UNITED STATES PATENT AND TRADEMARK OFFICE

Office Action Summary	Application No. 10/711,842	Applicant(s) REITER, MARKUS	
	Examiner THOMAS IRVIN	Art Unit 3657

Claims 1-3, 5, 7-9, 12, 15, and 16 are rejected under 35 U.S.C. 102(b) as being anticipated by Kamada (6,340,338).

FIG. 12

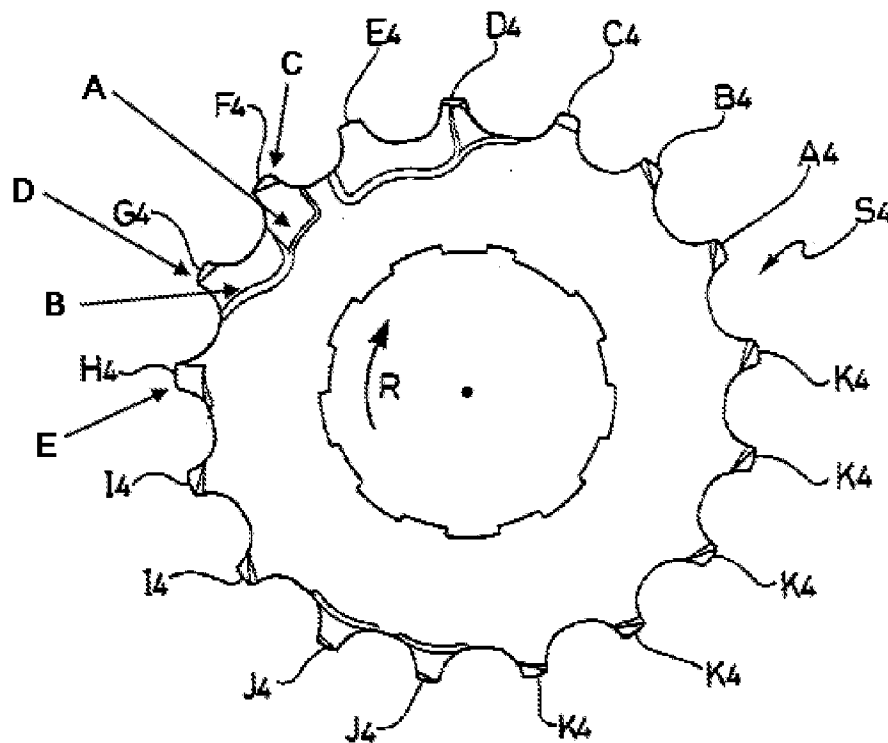
In Re claim 1, with reference to Fig. 3, 13, 14, and 12 (above), Kamada discloses a chainwheel assembly including a plurality of chainwheels (s1-s7) engageable with a chain (23) having successive alternating pairs of inner link plates and outer link plates connected by pins, the pins surrounded by rollers, the chainwheel assembly comprising: at least one smaller chainwheel (s3) having a plurality of teeth spaced about its circumference; and at least one larger chainwheel (s4) having a greater number of teeth spaced about its circumference than the smaller chainwheel, the larger chainwheel and the smaller chainwheel oriented relative to each other such that a distance between a center of the chain roller positioned between a pair of adjacent teeth on the larger chainwheel and the center of the chain roller between a pair adjacent teeth on the smaller chainwheel is substantially an integer multiple of the chain pitch, at least a first tooth (f4) of the pair of adjacent teeth (F4,G4) on the larger chainwheel includes a first lateral recess (A) having a first run-on ramp (see fig. 14), at least a second tooth (G4) of the pair of adjacent teeth disposed adjacent to the first tooth opposite the drive rotation direction including a second lateral recess (B) with a run-on ramp (see fig. 14).

In Re claims 2 and 3, see fig. 14.

In Re claim 5, see third tooth (H4) which includes a run-out chamfer (E).

In Re claim 7, see fig. 14.

In Re claims 8, 9, and 12, see deflection chamfers (C,D) on the first and second tooth (F4,G4) in fig. 12 above.

In Re claim 16, see chamfers (C,D,E).

As previously stated, in response to applicant's argument that that Kamada fails to disclose two run-on ramps configured to lift the outer link plate of a chain, a recitation of the intended use of the claimed invention must result in a structural difference between the claimed invention and the prior art in order to patentably distinguish the claimed invention from the prior art. If the prior art structure is capable of performing the intended use, then it meets the claim. In this case, the examiner believes that Kamada's recesses are understood to include run-on ramps that could lift the outer link plate of a chain as understood from the claim. Additionally, the examiner points out that the claims do not define the recesses and run-on ramps so as to define over the first and second recesses of Kamada.

FIG. 5

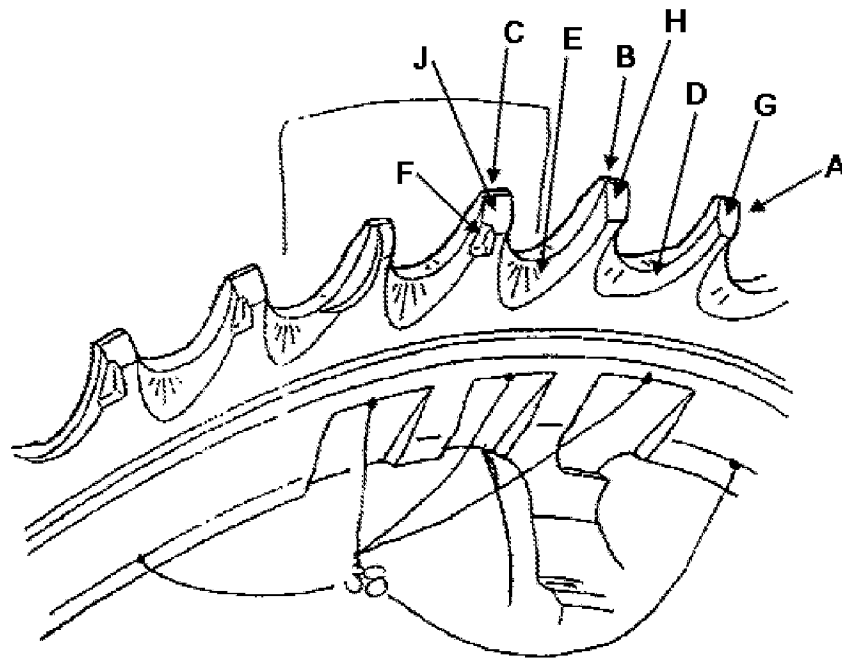
In Re claim 1, with reference to Fig. 5, above, Yahata discloses a chainwheel assembly including a plurality of chainwheels (see fig. 15) engageable with a chain (10), the chainwheel assembly comprising: at least one smaller chainwheel (50) having a plurality of teeth spaced about its circumference; and at least one larger chainwheel (40) having a greater number of teeth spaced about its circumference than the smaller chainwheel, at least a first tooth (A) of a pair of adjacent teeth (A,B,C) on the larger chainwheel includes a first lateral recess and run-on ramp (D), at least a second tooth (B) of the pair of adjacent teeth disposed adjacent to the first tooth opposite the drive rotation direction including a second lateral recess and run-on ramp (E).

In Re claims 2 and 3, see fig. 5.

In Re claim 5, see third tooth (C) which includes a run-out chamfer (F).

In Re claim 7, see fig. 5.

In Re claims 8 and 12, see deflection chamfers (G,H) on the first and second tooth (A,B) in fig. 5 above.

In Re claim 16, see chamfers (G,H,J).

In Re claim 24, the recesses are separate from each other.

As stated above, in response to applicant's argument that the recesses E and D of Yahata are not configured to lift the outer link plate of a chain, a recitation of the intended use of the claimed invention must result in a structural difference between the claimed invention and the prior art in order to patentably distinguish the claimed invention from the prior art. If the prior art structure is capable of performing the intended use, then it meets the claim. In this case, the examiner believes that Yahata's recesses are understood to include run-on ramps that could lift the outer link plate of a chain as understood from the claim. Additionally, the examiner points out that the claims do not define the recesses and run-on ramps so as to define over the recesses of Yahata.
